## **SPECIAL INFORMATION LEAFLET No. 948 PRODUCT SAFETY NOTICE**

### **A. ONE-TIME CHECK OF BTRU SEAR AND CORRECT ASSEMBLY OF RESTRICTOR CLAMPS ON STORED ENERGY FIRING UNITS DURING FUNCTION & LEAK TESTING OF EJECTION SEATS**

### **B. This Special Information Leaflet (SIL) is applicable to the following Ejection Seats only:**

**All Mk. 16 ejection seat types <sup>\*(1)</sup>**

Figure 1 – Incorrectly Cocked Sear – BTRU (Typical)

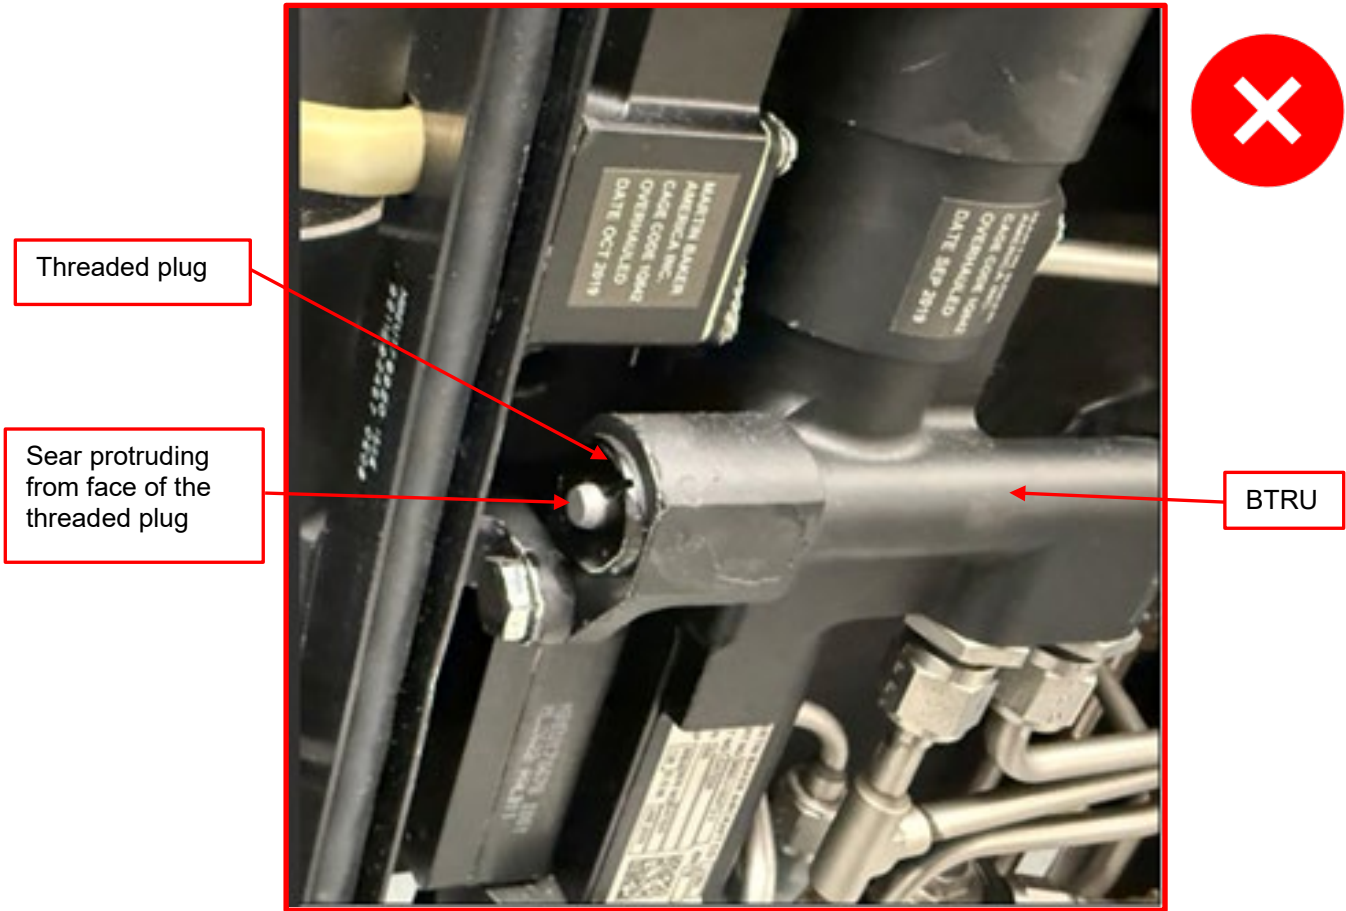
**C.2** Martin-Baker have been made aware by an Operator of an issue whereby a Barostatic Time-Release Unit (BTRU) was found partially cocked during seat arming. The sear retaining the spring-loaded firing pin was found to be protruding past the face of the threaded plug – see Figure 1 for a typical example of an incorrectly cocked sear. When correctly cocked, the face of BTRU the sear should not protrude past the face of threaded plug – see Figure 2 for typical example of a correctly cocked sear.

D.1.1.4 If inspection of the sear position is not satisfactorily passed – either examination results are inconclusive or protrusion of the sear is evident, reset the sear as below:

D.1.1.4.2 Using finger pressure or a non-metallic tool, push the sear flush with the face of the threaded plug.

Figure 2 – Correctly Cocked Sear – BTRU (Typical)

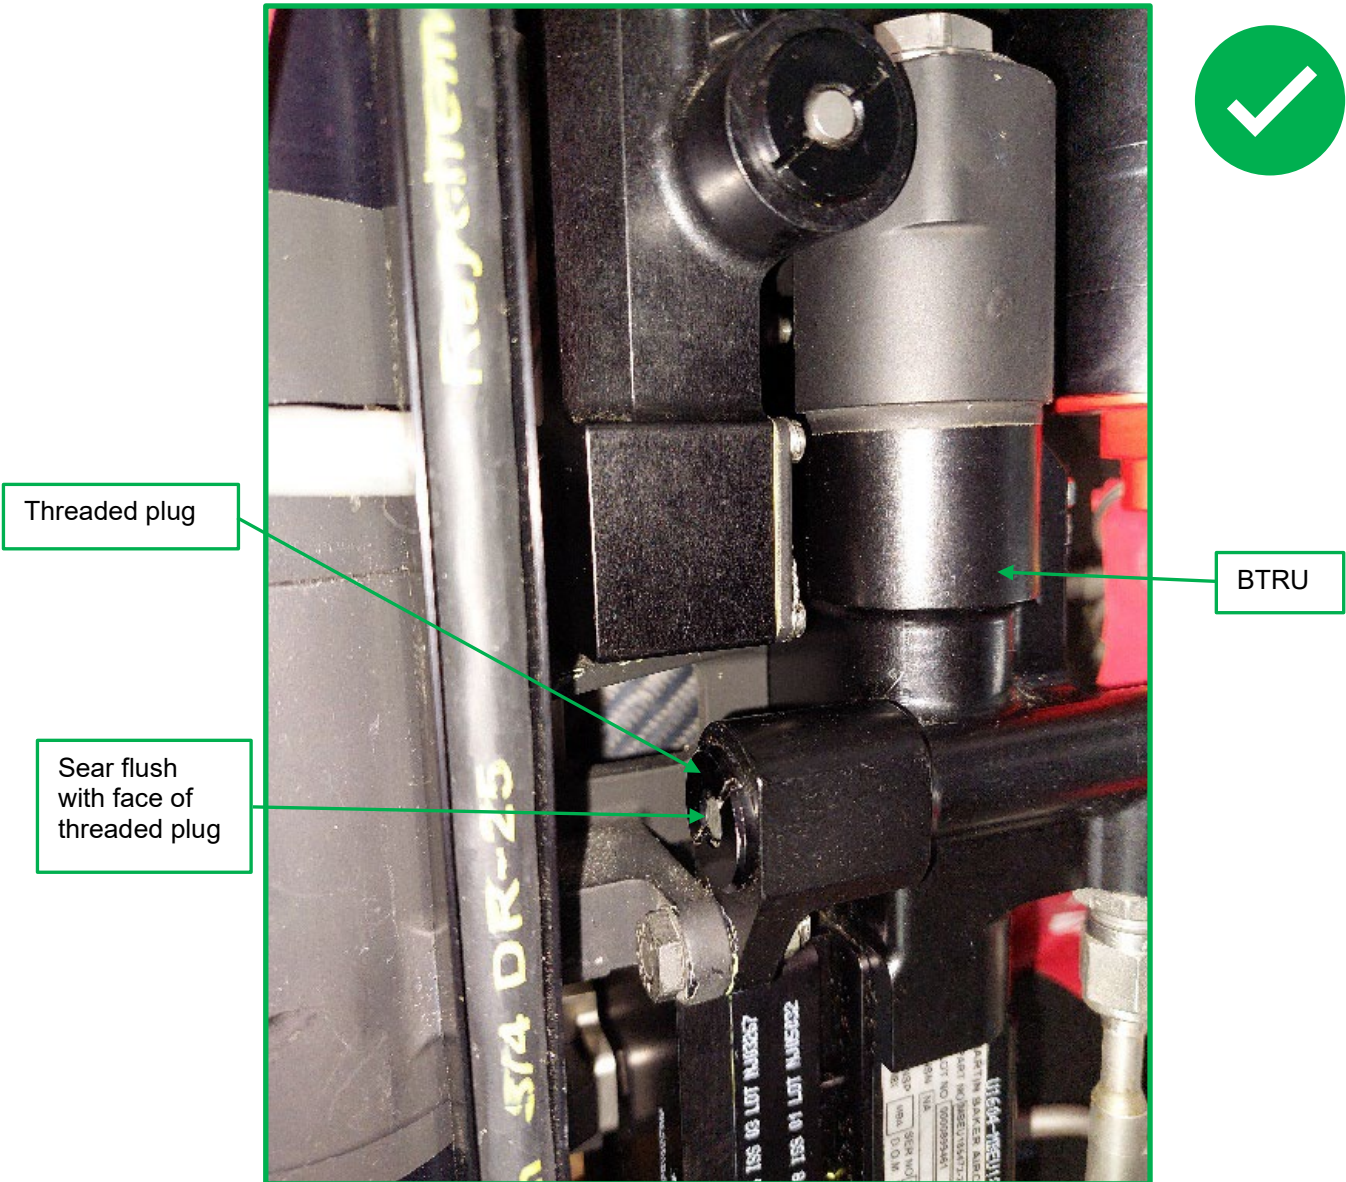
D.1.1.2.1 The BTRU sear is cocked when the end of the sear is level with the surface of the threaded plug (no protrusion). See Figure 2 for details.

- NOTES:**
- 1) The BTRU sear is cocked when the end of the sear is level with the surface of the threaded plug.
  - 2) By design, it is permissible for the BTRU sear to be sub-flush when fully cocked.

NOTE (1): By design, it is permissible for the BTRU sear to be sub-flush when fully cocked.

Figure 3 – Incorrect Installation of the Restrictor Clamp (Typical)

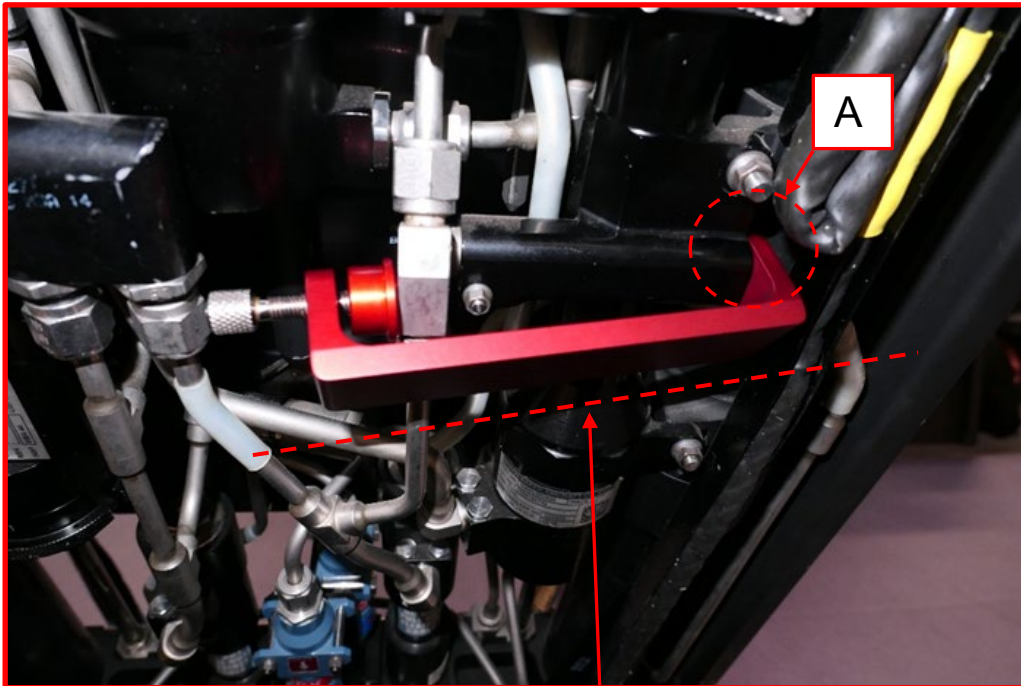
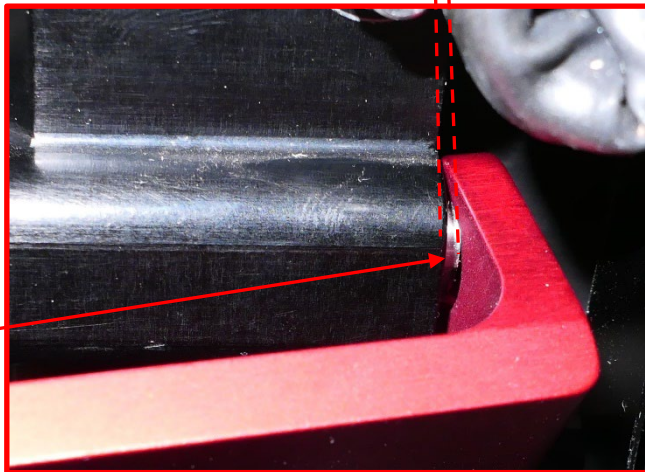
- C.3 Investigations conducted by Martin-Baker found that, during ejection seat function & leak test as part of scheduled maintenance, it was possible to move the sear to a partially cocked condition under gas pressure when using an incorrectly installed BTRU sear restrictor clamp, the face of the sear coming to rest against the inner face of the restrictor clamp. See Figure 3 and 4 for examples of incorrectly installed restrictor clamp allowing sear protrusion post function & leak test.

Restrictor clamp loosely assembled and/or at an angle, offset to the stored energy firing unit, allowing sear extraction – i.e. restrictor clamp **not** in correct alignment with the sear.

Gap between inner face of the restrictor clamp and face of sear allowing sear extraction.

**Sear protrusion.**  
Sear abutting inner face of restrictor clamp on application of gas pressure.

Figure 4 – Incorrect Installation of the Restrictor Clamp (Typical)

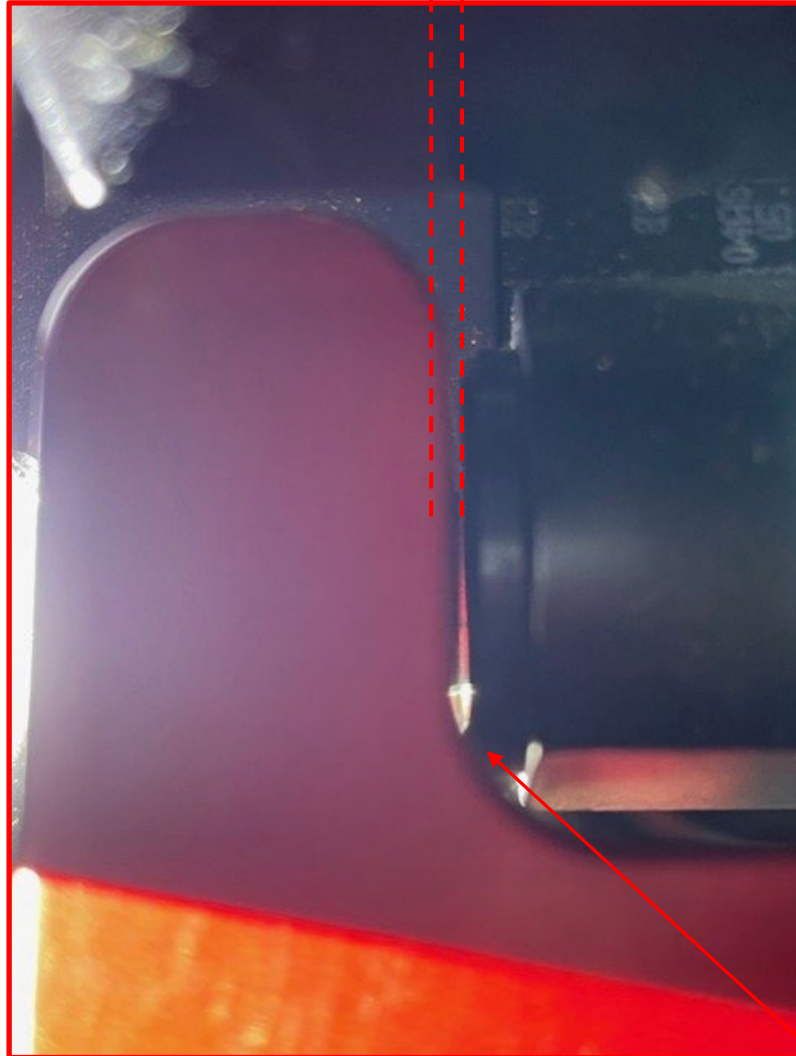
Off-set created due to device under test resting on inner radius of restrictor clamp.  
**False indication of correct installation of restrictor clamp.**

Restrictor clamp installed on stored energy firing unit.  
**Inner radius of clamp point contact between device and clamp.**

Figure 5 – Correct Installation of the Restrictor Clamp (Typical)

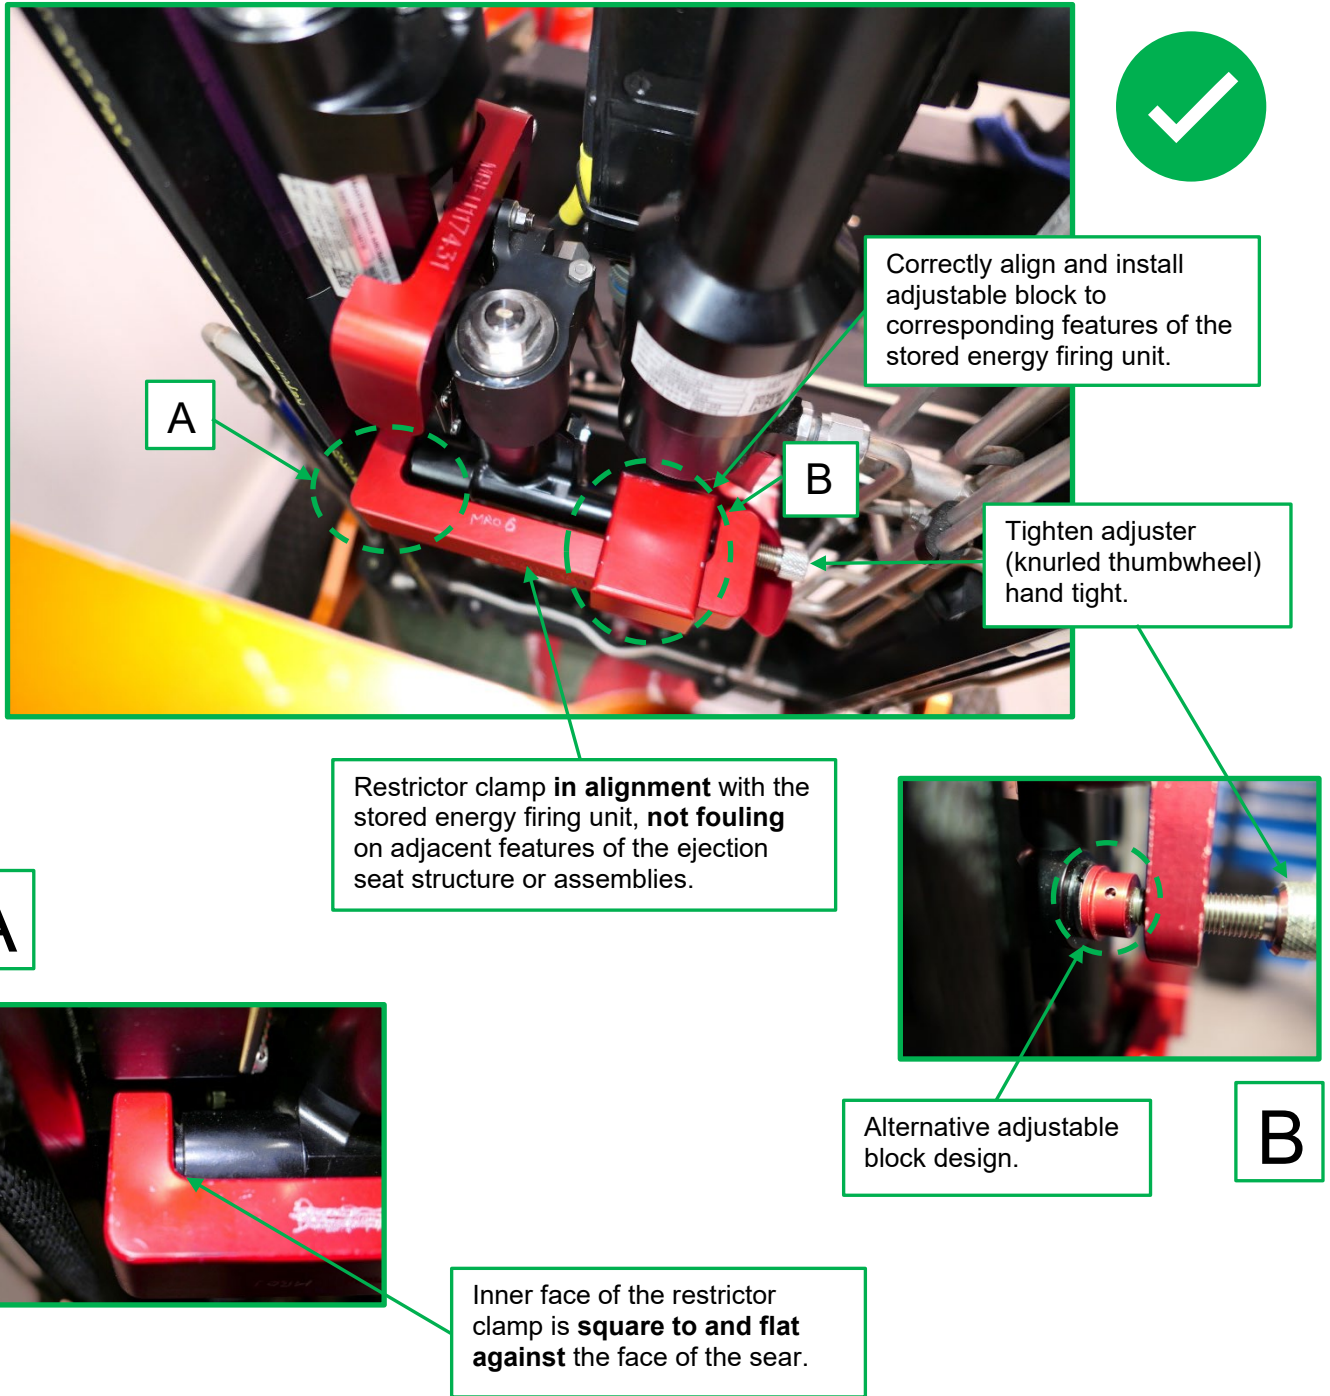
- C.4 Figure 5 provides guidance on correct installation of restrictor clamps, typical to ABU, BTRU and TDU assemblies.
- C.5 The consequence of an incorrectly cocked stored energy firing unit, as reported in a recent mishap event, is a potential un-commanded initiation of the parachute deployment and automatic harness release systems.

D.1.4.1 On installation of restrictor clamps to the ABU, BTRU and TDU (as applicable to ejection seat type) in preparation for seat function & leak tests, referring to Figure 5 below, the following actions shall be taken:

D.1.4.1.1 Ensure the correct restrictor clamp, by part number as referenced in the applicable Martin-Baker technical publication, is used to restrict the sear movement of the subject stored energy firing unit (ABU, BTRU or TDU).

D.1.4.1.2 Align the restrictor clamp with the stored energy firing unit. Install with the inner face of the restrictor clamp square to and flat against the face of the sear.

D.1.4.1.3 Correctly align and install the restrictor clamp adjustable block to the stored energy firing unit body.

**NOTE:** It shall be ensured that correct assembly of the restrictor clamp is not impeded by fouling contact with adjacent component parts/assemblies of the ejection seat.

D.1.4.1.4 Tighten the adjuster hand tight.

D.1.4.1.5 Check the restrictor clamp for looseness and misalignment with the face of the sear prior to function & leak test (step D.1.4.1.2 above and Figure 5 below).
